(I) THE FOLLOWING CONDITIONS OF PWD VIDE THE CE.WRD,CHENNAI REGION, CHEPAUK , CHENNAI -5. LETTER NO.DB / T5 (3) / F - I - MANGADU / 2019 / 24.07.2019, ARE TO BE COMPLIED BY THE APPLICANT BEFORE ISSUING OF THE LAYOUT APPROVAL BY THE COMPETENT AUTHORITY (LOCAL BODY)

MANGADU TOWN PANCHAYAT
LAYOUT OF HOUSE SITES IN S.Nos.181/1, 183/1A AND S.No.184/2 OF MANGADU VILLAGE.

CONDITION:- THE LAYOUT APPROVAL IS VALID SUBJECT TO OBTAINING SANCTION FROM THE LOCAL BODY CONCERNED		
P.P.D	NO.	89
L.O		2019
APPROVED		
VIDE LETTER NO	:	L1 / 19653 / 2018
DATE	:	/ 08 / 2019
 FOR SENIOR PLANNER (MSB/LAYOUT) CHENNAI METROPOLITAN DEVELOPMENT AUTHORITY

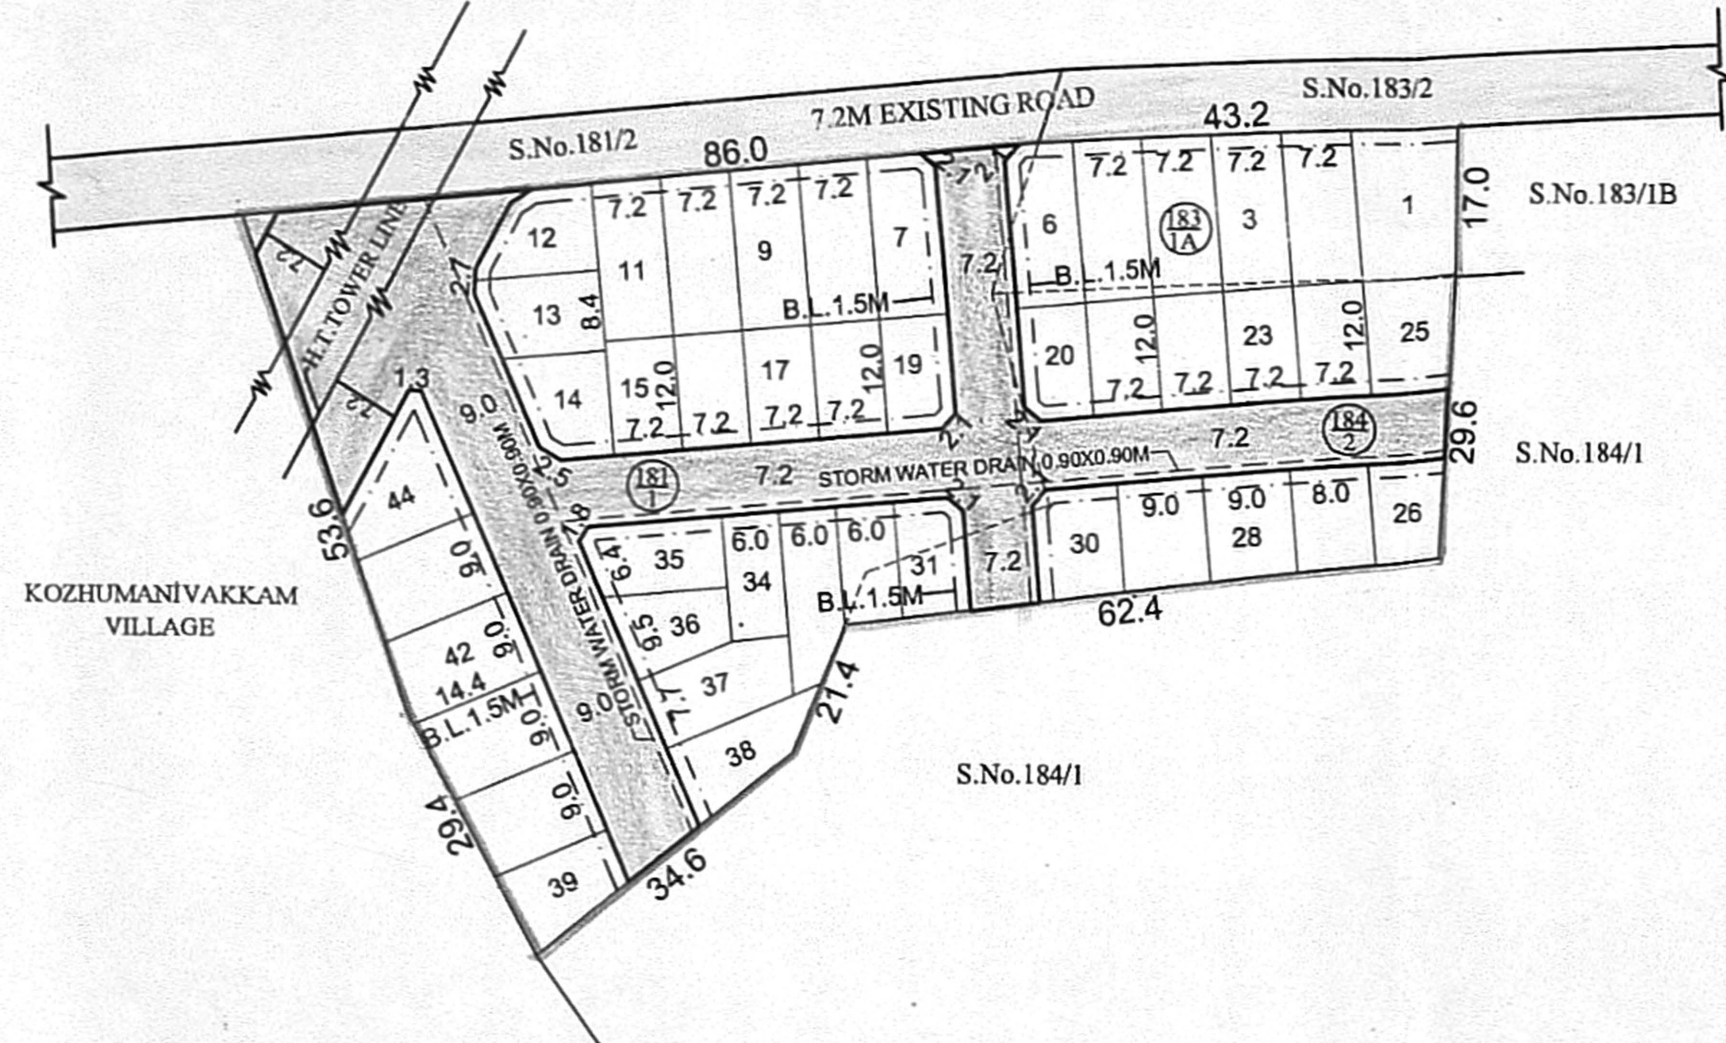
- 1.The existing ground level of the site should be raised to minimum level of (+) 18.300m (i.e) 0.90m below sill level of sluice No.6 (Kolumanivakkam Branch Channel) of Chembarambakkam Tank i.e., (+)19.200m with an average filling 0.93 to 0.96m with layers of not more than 0.30 meter depth to achieve required degree of compaction to the entire area of the applicant land to avoid inundation during the heavy rains. The all-round pavement level within site should not be less than (+)18. 300m.

- 2.The applicants should prepare the layout proposal by considering the suitable internal storm water drainage network of size not less than 0.90m x 0.90m (peripheral & lateral), rainwater harvesting, roads (peripheral & lateral) and sewerage alignment & garbages/debris and other solid waste management as per norms in existence within the applicants land according to the existing rules in force and should get proper approval from the competent authority without fail.

- 3.The sewage or any unhygienic drainage should not be let into the drain/channel at any cost and the debris and construction materials should not be dumped into the drain/channel obstructing free flow of water. The applicant should make drain networks at their own cost and the same is to be connected to the natural storm water drainage or channel/drain.

- 4.The applicant should clearly demarcate the boundary of their land before the commencement of any developmental activities in presence of Revenue authorities and PWD/WRD authorities concerned without fail and should not encroach the Government land/ channels viz Mangadu to Nellithope Road on Northern side in S.F.No. 181/2 & 183/2 of Mangadu village, channel in S.F.No. 185 partly of Mangadu village on Southern side, channel in S.F.No.37 & 39, in S.F.No.38 other Government land& S.F.No. 40&41 as road on Western side of Kolumanivakkam village and the channel in S.F. No. 178 Mangadu village on North- West side of the applicants site. The applicants land should be maintained as it is in the Revenue records and should not encroach the channel/road/Government lands abutting the applicants site.

- 5.The Channel in S.F.No. 39 on Western boundary of the applicants land should be completely desilted and resectioned by constructing retaining wall on either side of the channel as per the FMB at the applicant's own cost. The bed level of the above channel should be ascertained and restored before commencing the development activity in the presence of the concerned PWD/WRD Executive Engineer. Moreover, the width of entire channel as per Revenue records (FMB) along & within the stretch of applicants land should be maintained properly without any change and no encroachments.

- 6.The Government channel in S.F.No.39 stretch abutting the applicant boundary should be marked as per FMB and monitored and maintained by the applicant at his own cost. The width of the channel should be maintained without encroachment as per Revenue records and the hydraulic parameters of the field channel should be maintained. The applicant should make necessary periodical arrangements for free flow of water through the existing channel to the downside area within the proposed layout site. Also the applicant should de-silt the channel periodically and remove the obstruction then and there without any hindrance for free flow of water at their own cost within the proposed land, after the completion of project also.

- 7.During preparation of layout roads, specifically the peripheral layout road / open space should be provided in the applicant's site along the channel course which is necessary for carrying the maintenance/improvement/development works by PWD / WRD in future periodically.

- 8.The applicants should not object to provide adequate passage in the channel side to facilitate access to the site without any hindrance to the movement of heavy machinery carrying the maintenance / improvement / development works by the PWD/WRD in future periodically.

- 9.The applicants should not object at any time for the maintenance work / improvements work of the channel to be carried out by PWD/WRD. The applicant should give an undertaking in writing to the effect that the above proposal will not obstruct in case any maintenance / improvement / development works as per Revenue records (FMB) are to be carried out by PWD/WRD in future periodically.

- 10.The applicants should not carry out any other cross masonry structures across the channels without prior permission from PWD/WRD.
- 11.The permission granted to the applicants should not be altered / modified / changed to any others. Based on the Revenue records submitted by the applicants, the permission is granted. If any documents seem to be fake / manipulated / fabricated, in future the above permission will be cancelled without any correspondence. Hence, the applicants are solely responsible of genuinity of the documents submitted. If there is any discrepancy or any other encroachments activities held at the applicant site in the future.

- 12.The PWD/WRD officers should be allowed to inspect the site at any time during execution and thereafter if necessary. Advance intimation should be given to the PWD/WRD officers concerned before commencement of work. The necessary setback distance should be provided as per the norms in existence and as per the rules in force of CMDA.

- 13.The applicants should abide by the rules and regulation of the PWD / WRD from time to time. The applicant should also abide court of law of both State & Central Government from time to time.

- 14.The applicants for their land should get a clearance certificate from the Revenue department to make sure that the site is not an encroached property of the water body. The applicants lands are seems to be ryotwari land which would be classified as dry lands. Hence, these lands are to be converted into other zone from the agricultural zone by the competent authority.

- 15.The applicants should not object at any time for the maintenance work / improvements work of the channel to be carried out by PWD/WRD. The applicant should not dump the garbages / debris in the channel and avoid the sewage water into the channel, etc.,

- 16.The truthness of the document received from the applicant in respect to the ownership is purely of applicant responsibility and it is only for reference purpose to this department. The legal validity of this document should be verified and ensured by the Development / Revenue authorities

- 17.Failing to comply with above conditions, PWD/WRD reserves rights to withdraw the Technical opinion with NOC on Inundation point of view for the above proposed site and in event the applicant shall not be eligible for any compensation whatsoever and as well as legal entity.

(II) LOCAL BODY SHOULD ENSURE COMPLIANCE OF ALL THE CONDITIONS STIPULATED BY PWD IN THEIR LETTER NO.DB / T5 (3) / F - I - MANGADU / 2019 / 24.07.2019 AND SHALL OBTAIN A LETTER FROM PWD CONFIRMING THE COMPLIANCE OF THE CONDITIONS BEFORE THE SANCTION AND RELEASE OF THE LAYOUT.
